Oakdale South Estate – Review of the SLR September 2015 Noise Impact Assessment

This letter presents a summary of my review of the SLR Report:

- *DA Noise Impact Assessment, Oakdale South Estate, Milner Avenue, Eastern Creek, Report Number 630.11166, Revision 2, 8 September 2015*

Figure 1 SLR noise logging locations (extract from SLR Report)

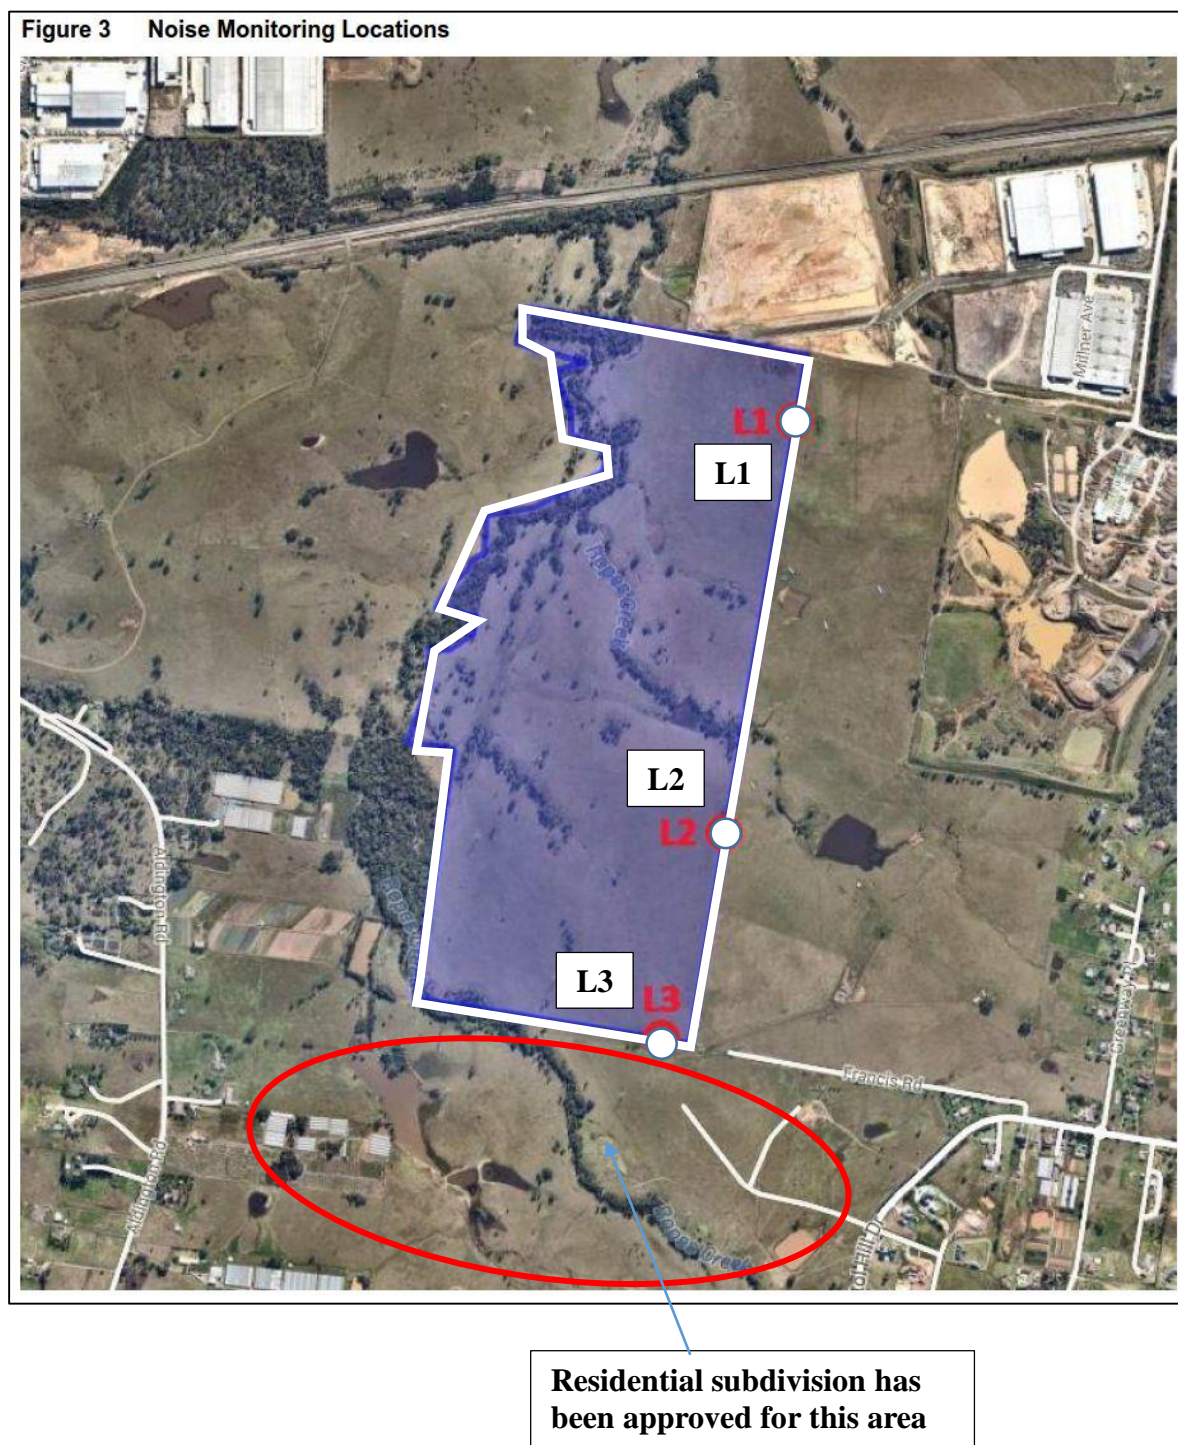
The background noise monitoring carried out by Wilkinson Murray found frequent periods during night-time when background sound levels were below 30dBA. The SLR Report assumes that the background sound levels are:

- 32dBA for assessment of operational noise;
- 44dBA for assessment of sleep disturbance criteria.

At the very least, the noise loggers used for the SLR assessment should have had filters to exclude insect noise. In addition, night-time sound level measurements should have been carried out once it was clear that the background sound levels were anomalous.

Figure 1 and Figure 2 show the two relevant sites for the two impact noise assessments and the noise logging locations used by SLR and WMPL, respectively.

Further, the planning authorities have not considered the cumulative noise impacts of both of the proposed industrial sub-divisions shown in Figure 1 and Figure 2. This is a gross oversight since it is known and understood that the whole area north and north-west of Francis Road will be developed for industrial use. To consider each development individually is simply to understate the cumulative noise impacts.
